## Planning Officer's Report - LDCA FEBRUARY 2021

<b>APPLICATION</b>	<b>2020/77</b> – Proposed Construction of a Prefabricated Steel Building for Drainage Depot including minor Earthworks for access and construction of the base slab and also a vehicle turning area.
<b>PERMISSION SOUGHT</b>	Permission in <b>Full</b>
<b>REGISTERED</b>	2 <sup>nd</sup> October 2020
<b>APPLICANT</b>	Connect St Helena Ltd
<b>PARCEL</b>	FP0468
<b>SIZE</b>	2.84 (1.116ha)
<b>LAND OWNER</b>	Crown Estates
<b>LOCALITY</b>	Red Hill Treatment Plant Work Site
<b>ZONE</b>	Intermediate Zone
<b>CONSERVATION AREA</b>	None
<b>CURRENT USE</b>	Treatment Plant Work Site
<b>PUBLICITY</b>	The application was advertised as follows: <ul style="list-style-type: none"><li>▪ Independent Newspaper on 9<sup>th</sup> October 2020</li><li>▪ A site notice displayed in accordance with Regulations.</li></ul>
<b>EXPIRY</b>	23 <sup>th</sup> October 2020
<b>REPRESENTATIONS</b>	None Received
<b>DECISION ROUTE</b>	<del>Delegated</del> / LDCA / EXCO

**Diagram 1: The Revised Layout of the Proposed Storage Building**

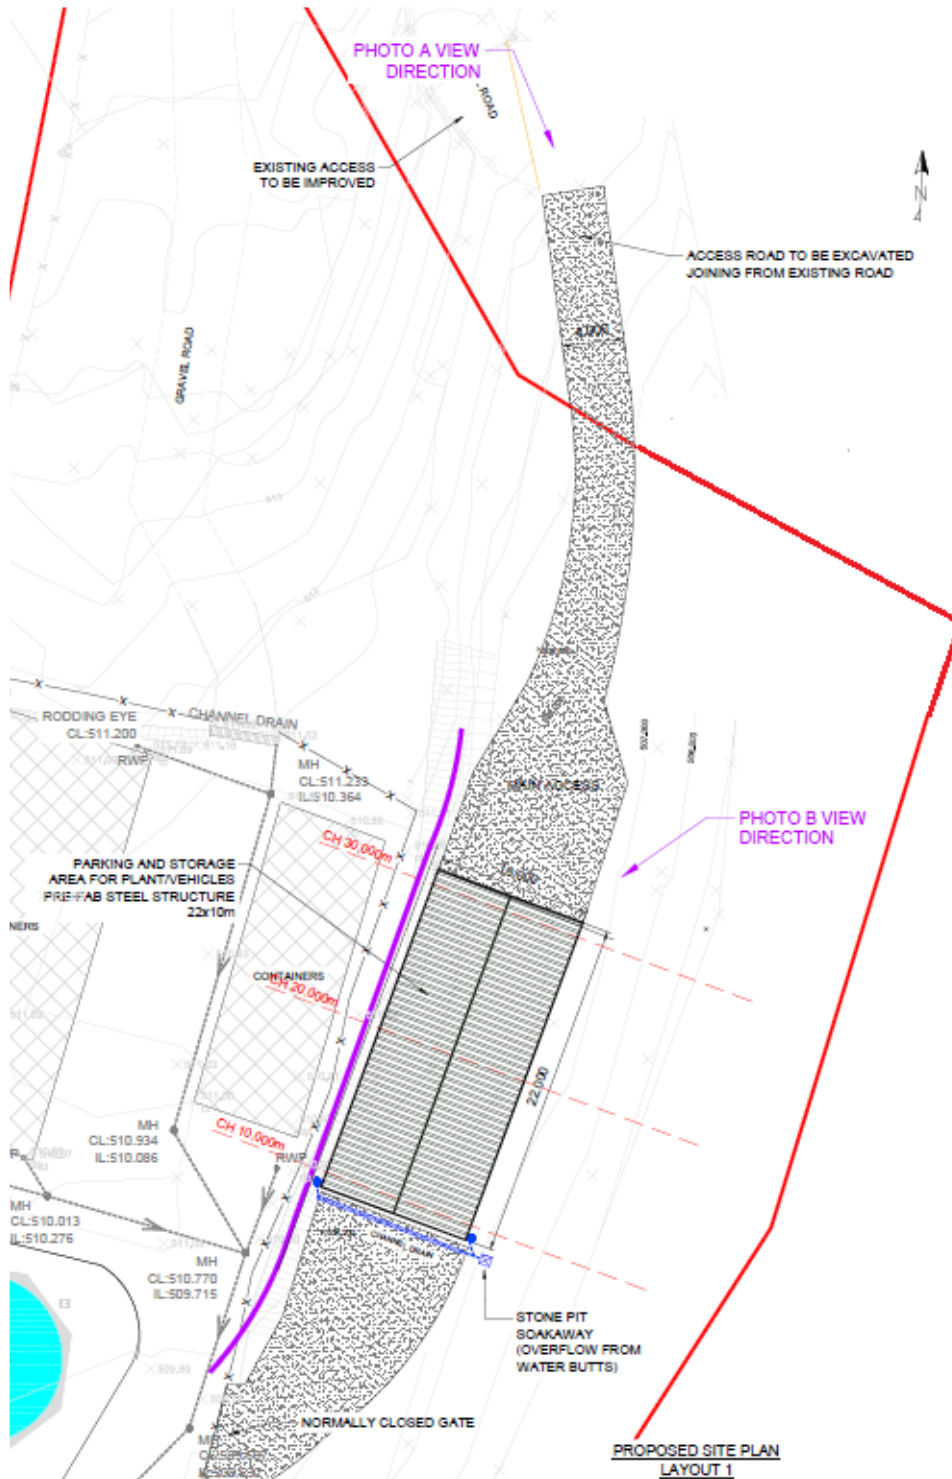
The revised details now building being moved closer to the western side fence against the existing containers. The vehicular access to serve the building has also been revised and is now longer starting further north from previous position. There is also

now wider platform that enable landscaping on the eastern side of the building to further reduce the visual impact of the development on the landscape.

It is considered that with the proposed building now being placed closer to the fence on the western side of the site, there is potentially a greater opportunity for a meaningful landscaping to be provided. The issues raised regarding the revised
